Wisconsin Department of Transportation

Proposal #06: 5350-02-70, WISC 2024218
C Janesville, Center Avenue
Nicolet Street to Court Street
USH 51
Rock County

Letting of February 13, 2024

This is Addendum No. 01, which provides for the following:

Addendum No. 01
 ID 5350-02-70
 Revised Sheet 29
 January 24, 2023

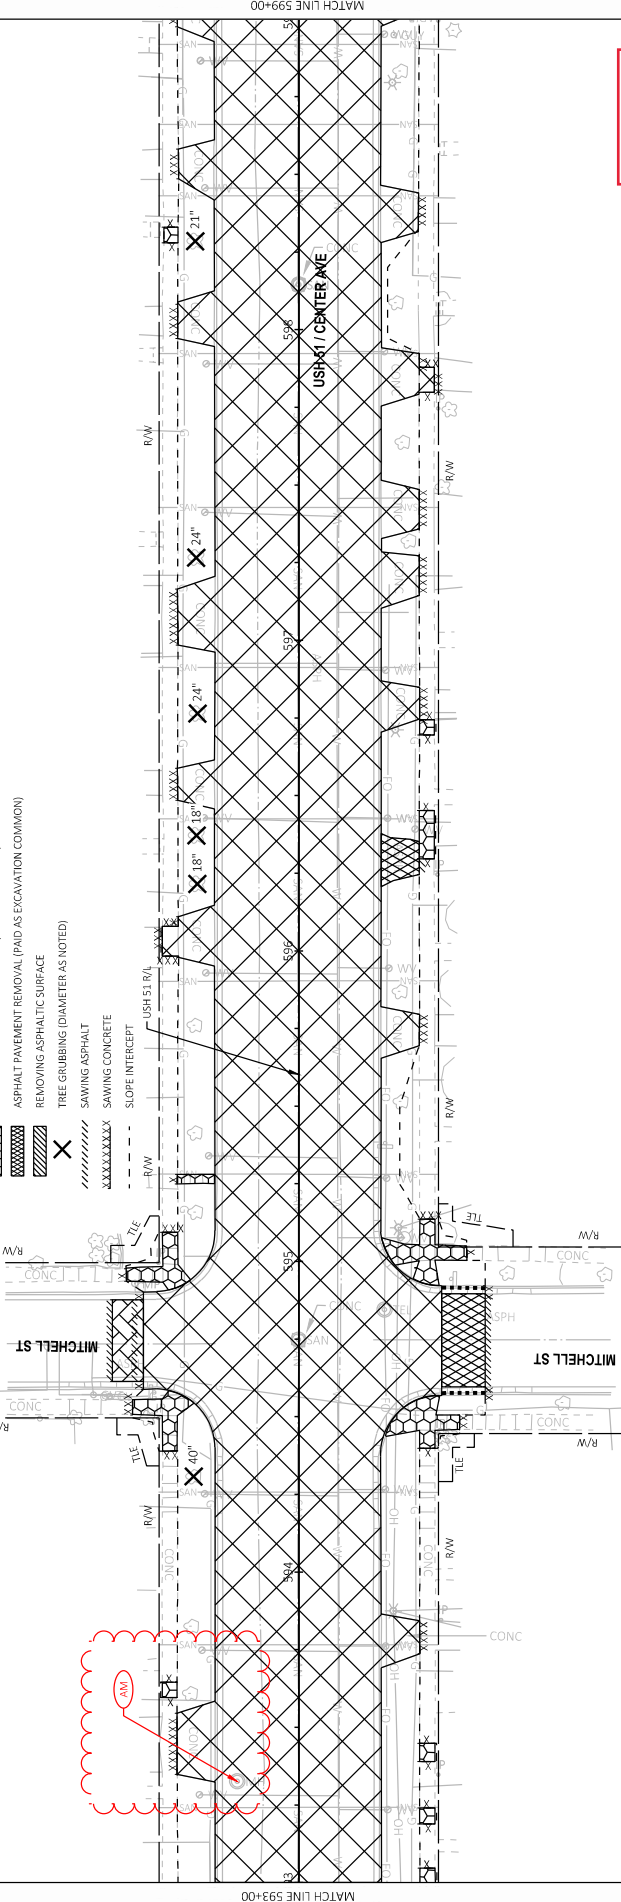
Revised Plan Sheets	
Plan Sheet	Plan Sheet Title (brief description of changes to sheet)
29	Removals: added additional manhole for abandoning
262	Miscellaneous Quantities: Revised storm sewer structures table
263	Miscellaneous Quantities: Revised Abandoning Manholes quantity
